RE: Approval of Sign in Skyline Drive

Subject: Request to the Board of Selectmen for Approval of Sign in Skyline Drive

**SKYLINE DRIVE
DEFINITIVE SUBDIVISION
ACTON, MASSACHUSETTS**

PROPOSED MONUMENT SIGN & SKYLINE DRIVE 1/2" = 1'-0"

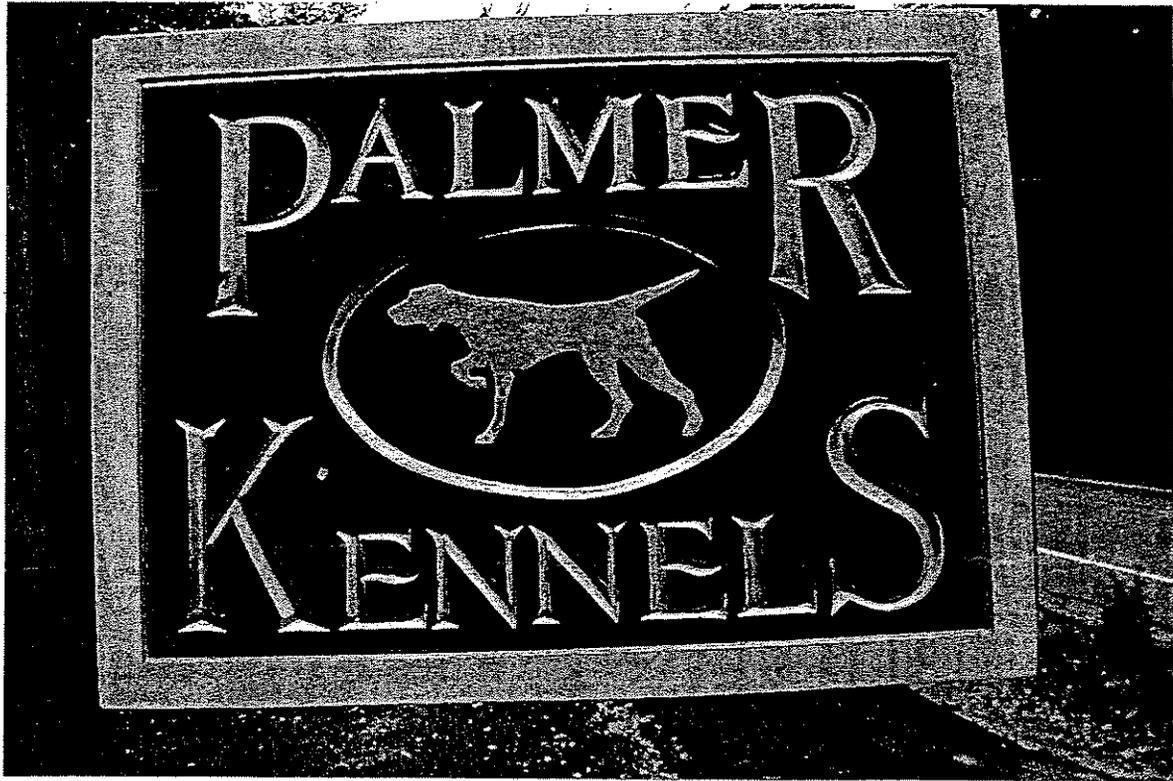
I recommend approval of the requested business sign for QRCC and Palmer Kennels, provided that the temporary signs in that Skyline Drive/Great Road intersection area will be removed. Following are the facts and circumstances, and my opinions that lead me to this recommendation:

option impossible without a variance for height and/or setbacks from the right-of-way line. The surrounding land falls off very quickly and steeply from the edge of the street (or from behind the sidewalk on Great Road) into adjacent wetlands 10 feet below. Even if variances were granted, the resulting sign would look awkward and out of place. While Skyline Drive is a street, it functions more like a business driveway. The business sign is proposed in a logical and practical location. If built as proposed, it would add a touch of class to the Skyline Drive entrance.

5. The proposed sign meets the by-right dimensional standards for business center signs in accordance with sections 7.8.4 and 7.8.5.2 of the zoning bylaw. Thus, it seeks to fit in with the general context of business signage on Great Road and does not try to stand out more than any other sign on Great Road.

I would like to inform you that the Board of Selectmen has approved the business sign for QRCC and Palmer Kennels in Skyline Drive, as presented.
